COUNCIL ASSESSMENT REPORT

Panel Reference	2017SCL021
DA Number	33.2018.1
LGA	Woollahra Council
Proposed Development	Demolition of all existing commercial buildings & construction of a new six (6) storey mixed-use building including 2 retail tenancies on ground floor, 5 storeys containing 23 residential units above, with 2 levels of below ground basement car parking, vehicular access via Gumtree Lane, provision of a through-site pedestrian link, and associated landscaping
Street Address	21, 23-25, 27 Bay Street DOUBLE BAY
Applicant/Owner	Pilmyth Pty Ltd; Thinqnet Bookings Pty Ltd (Owner) Thinqnet Bookings Pty Ltd c/o MHN Design Union (Applicant)
Date of DA lodgement	05.02.2018
Number of Submissions	Eight (8) – Including two (2) letters of support
Recommendation	Refusal
Regional Development Criteria (Schedule 4A of the Environmental Planning and Assessment Act 1979)	Capital Investment Value of \$22,290,000 (CIV > \$20 Million; Development applications lodged prior to 1 March 2018)

DEVELOPMENT APPLICATION ASSESSMENT REPORT

PANEL REFERENCE	2017SCL021
FILE No.	DA33/2018/1
ADDRESS	21, 23-25 & 27 Bay Street DOUBLE BAY
COUNCIL WARD	Double Bay
SITES AREA	820m ²
ZONING	B2 Local Centre
PRO

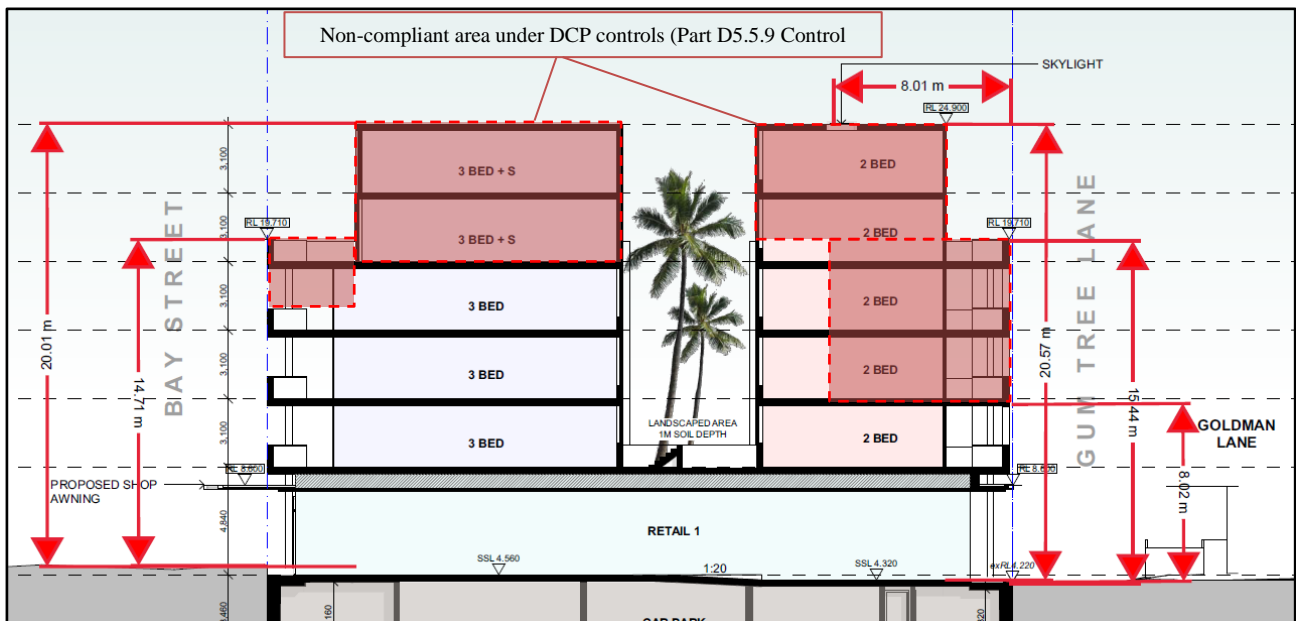
In the Double Bay Centre there are currently a few examples of relatively large scale developments (including the Cosmopolitan Building on Knox Street, the Kiaora Lands Development on New South Head Road and the Intercontinental Hotel and the George's building on Cross Street). The Council has also recently issued development consent for shop-top housing developments 6 storey in height on Cross Street (Nos.16-18 and Nos.20-26).

Notwithstanding this, these buildings are anomalies within the centre which is typically of low-scale and up to 4 storeys in height.

The proposal excessively exceeds the Height of Buildings and Floor Space Ratio development standards prescribed by Woollahra Local Environmental Plan 2014 (WLEP). Inevitably, it results in a building envelope that exceeds the site specific envelope controls prescribed by the Woollahra Development Control Plan 2015 (WDCP). One of the key objectives of this DCP (Part D5.1.3) states, *"O7 To ensure that new development is compatible with the existing built form, and streetscape and village character..."*.

Proposed Section (Source: MHDUNION; Overlay: Woollahra Council)

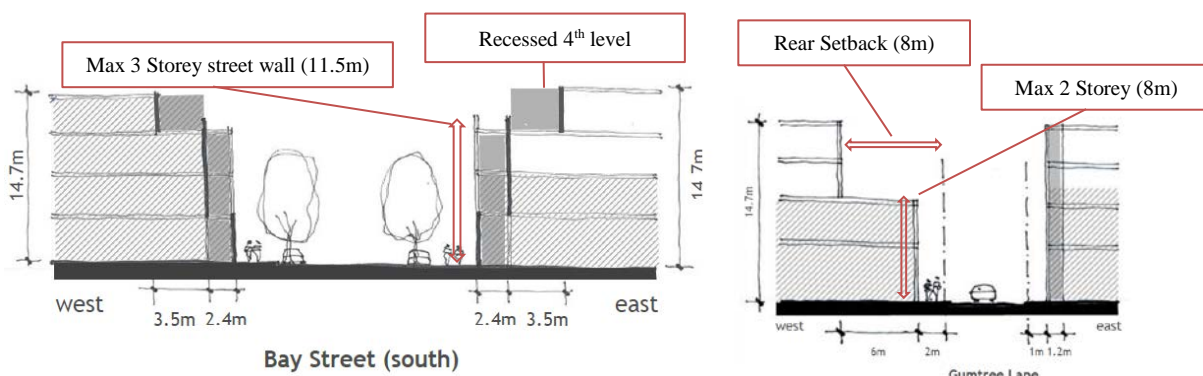
Following is a section comparing the proposed development against the prescribed building envelope controls in the WDCP for this locality:

The proposal does not satisfy the WDCP’s stated key objective or the desired future character for this locality. It also does not provide a satisfactory contextual response to the existing nor the desired future character of Bay Street (South) and Gumtree Lane immediately adjoining the subject sites.

Section A – Indicating Building Height Limit and area of non-compliance (Source: Plans – MHDUNION; Overlays: Woollahra Council).

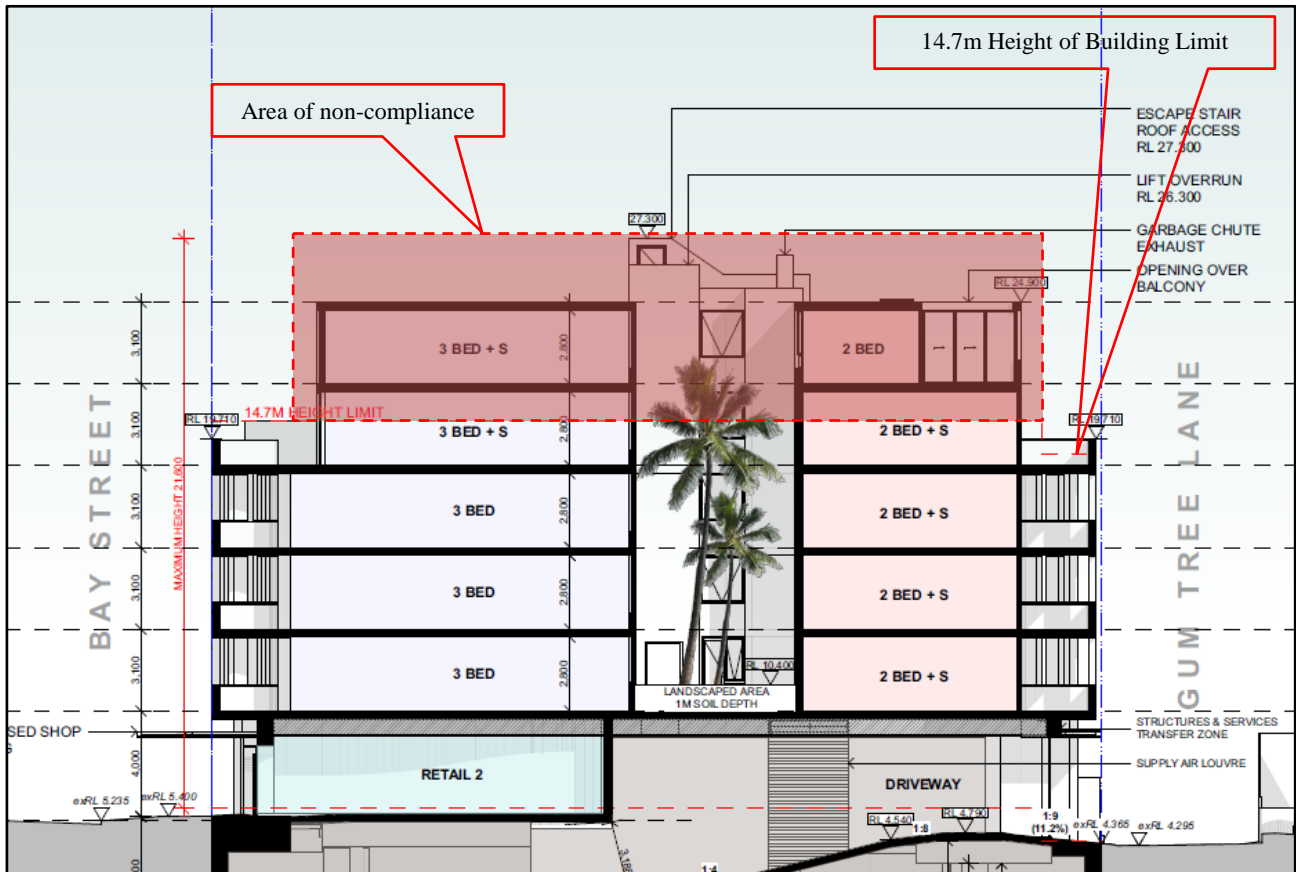
The proposal does not comply with the maximum building height prescribed by Part 4.3(2) of Woollahra LEP 2014. A Clause 4.6 written request has been submitted by the applicant and is assessed below.

Part D5.4.4 Bay Street (south)

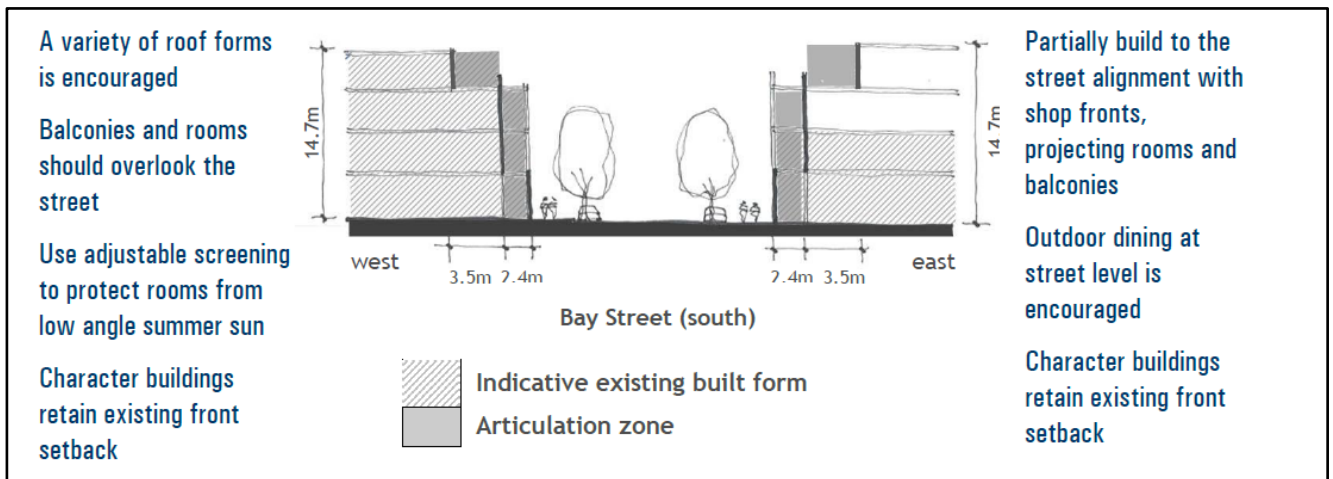
The proposed development does not achieve the Bay Street – Desired Future Character, Objective a), as the proposal does not maintain a three-four storey built form fronting Bay Street, nor does it provide a recessive upper floor level, as envisaged by the DCP.

The proposal therefore fails to satisfy the relevant criteria prescribed by this part.
